CITY OF NEW ALBANY, FRANKLIN COUNTY, OHIO
FINAL DEVELOPMENT PLAN
FOR
THE COURTYARDS AT HAINES CREEK
FIRE TRUCK TURNING MOVEMENTS

Subject: Courtyards at Haines Creek
Review Response Letter #2

Items from Planning Commission Staff Report – October 16, 2023:

NOTE:

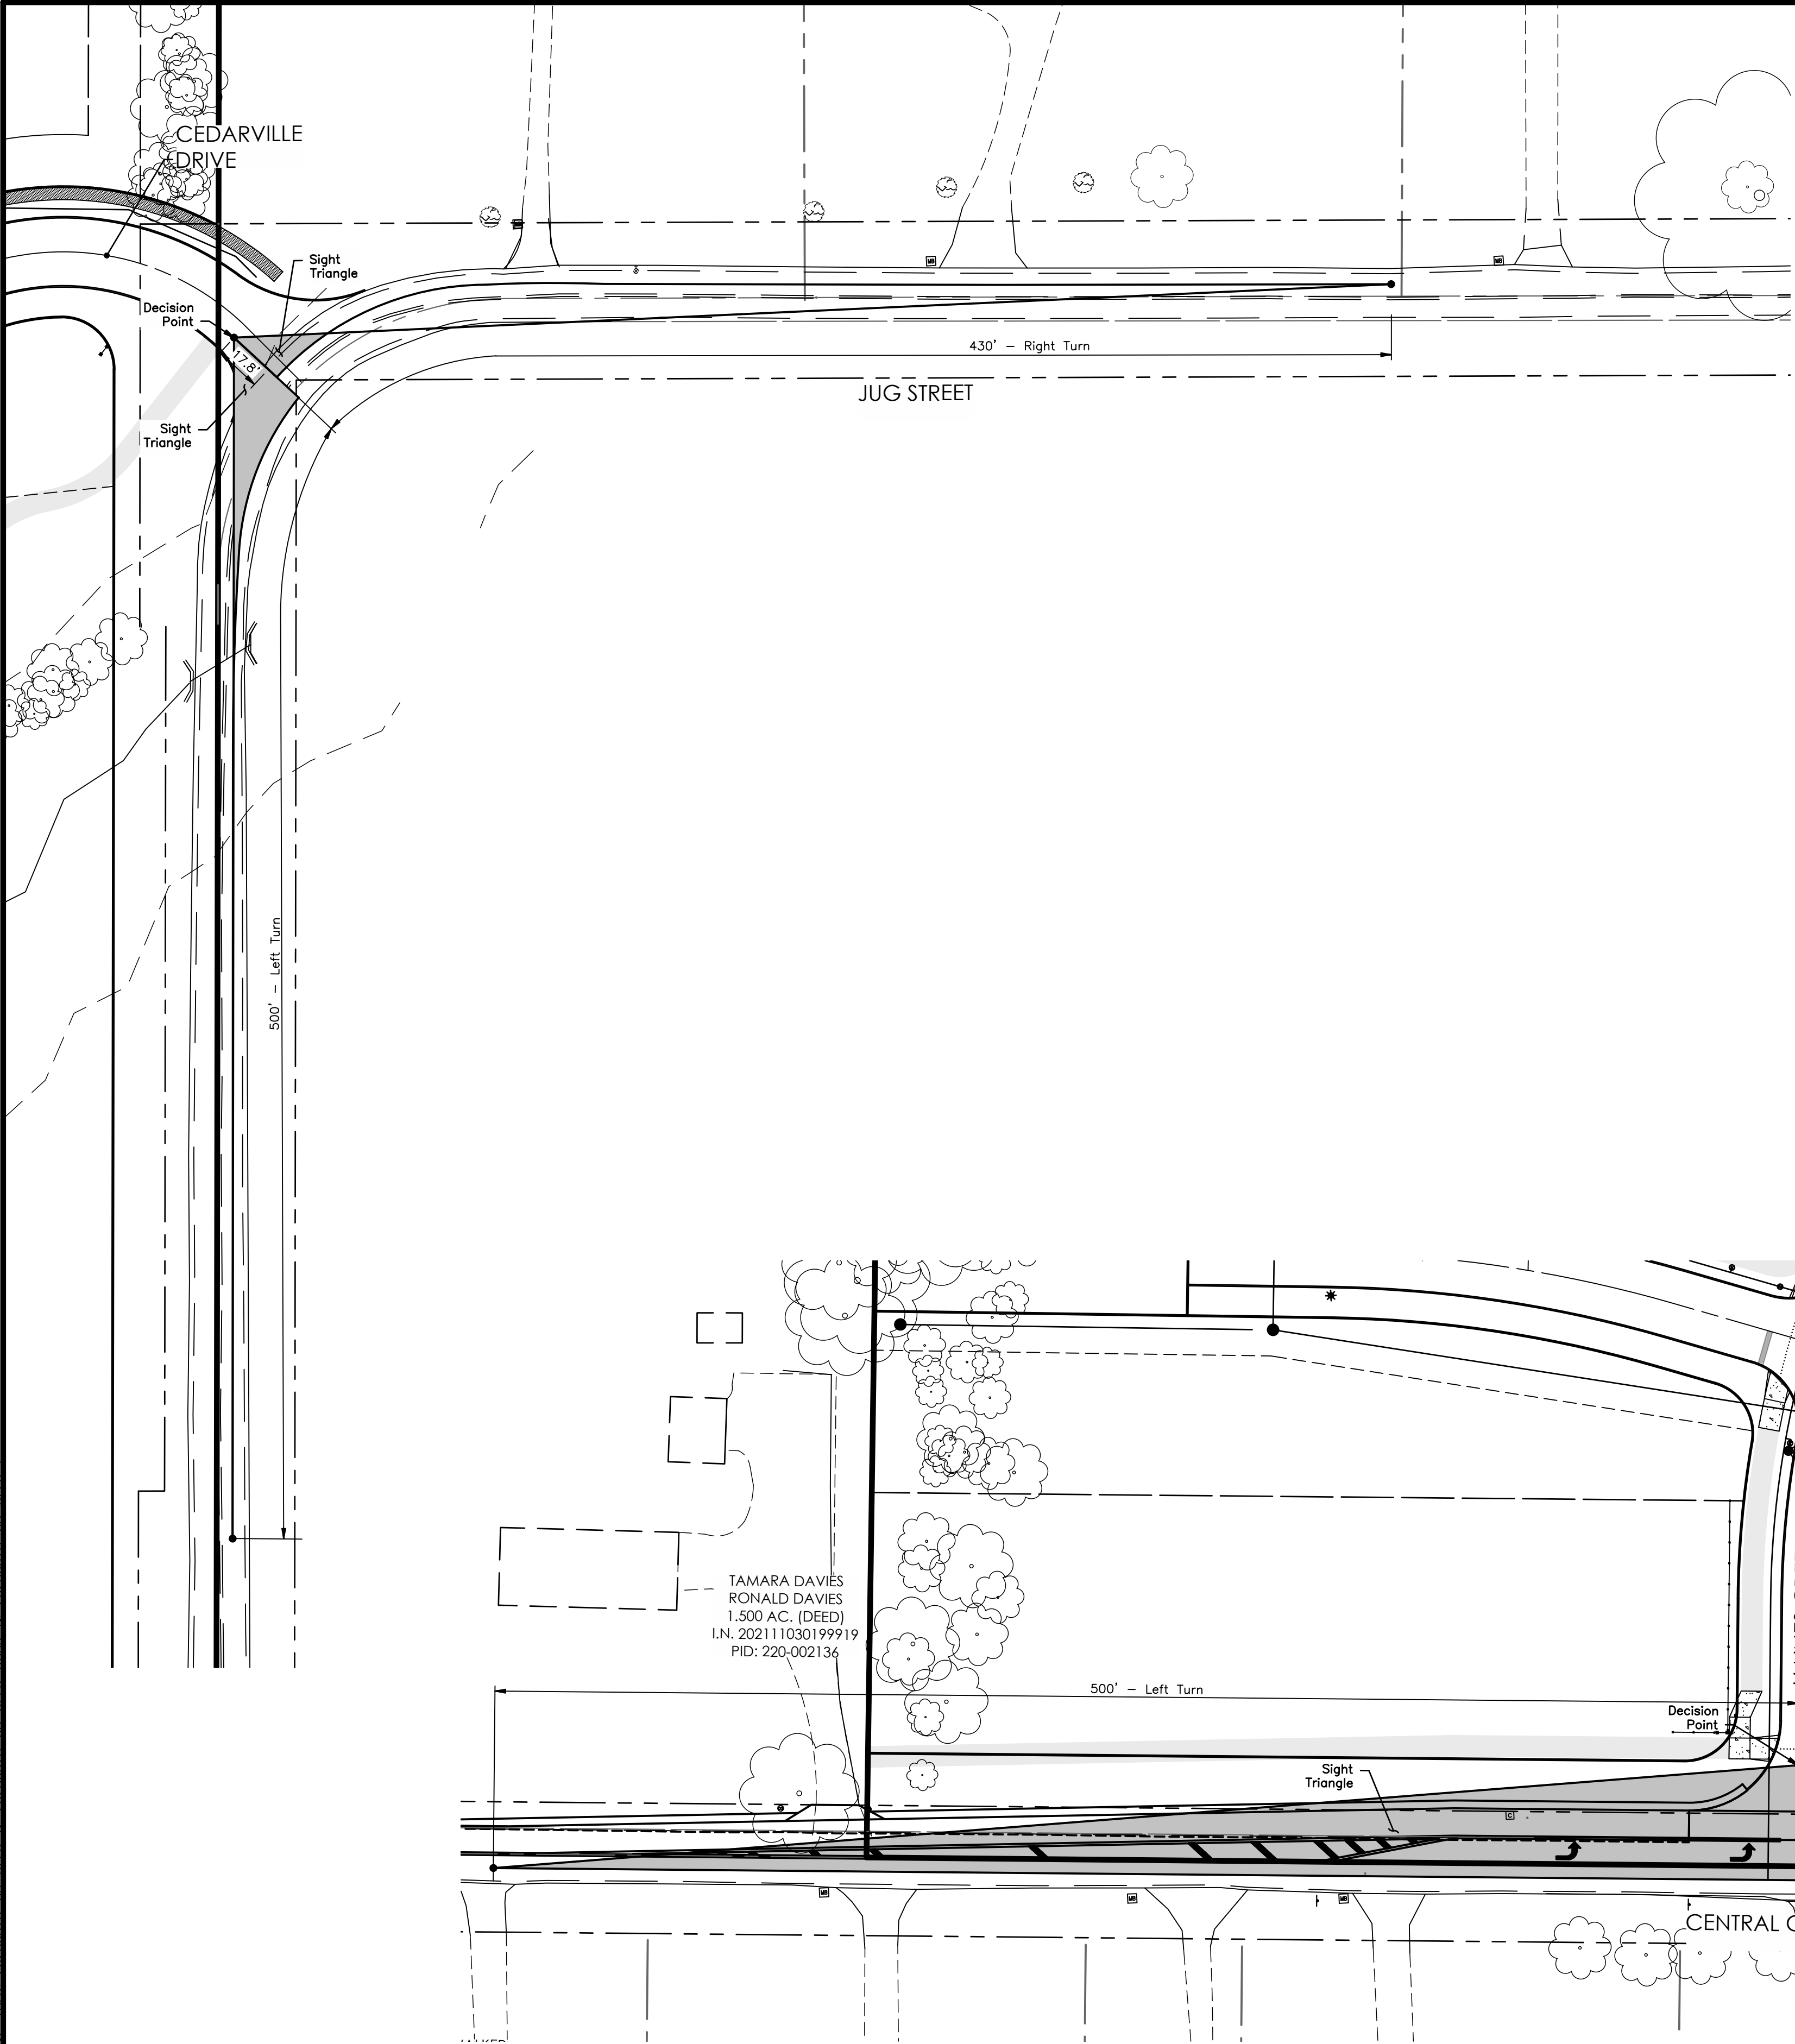
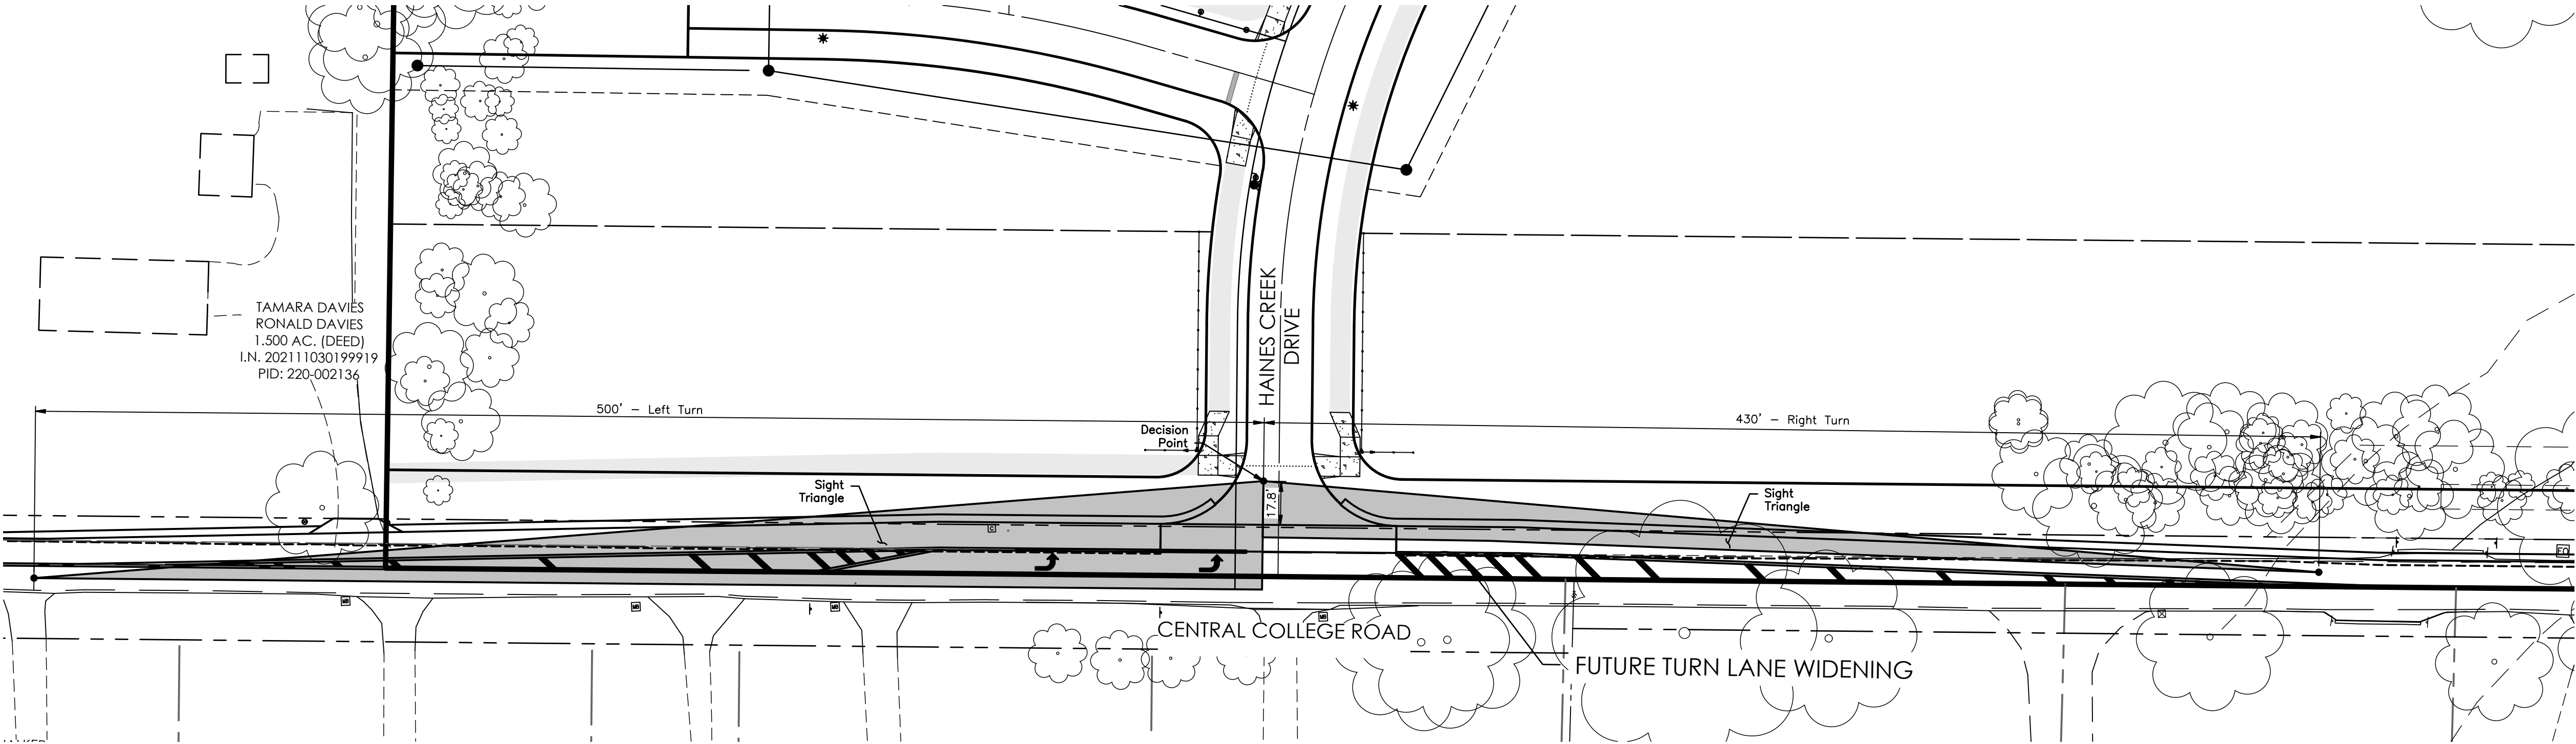
8. Sheet 7 of 16. Add site distance triangles at the curb cuts off of Central College Road and Jug Street. Remove landscaping and fencing that may impede motorist view.

Response: *Sheet 23 has been included and shows site distance triangles at each entrance.*
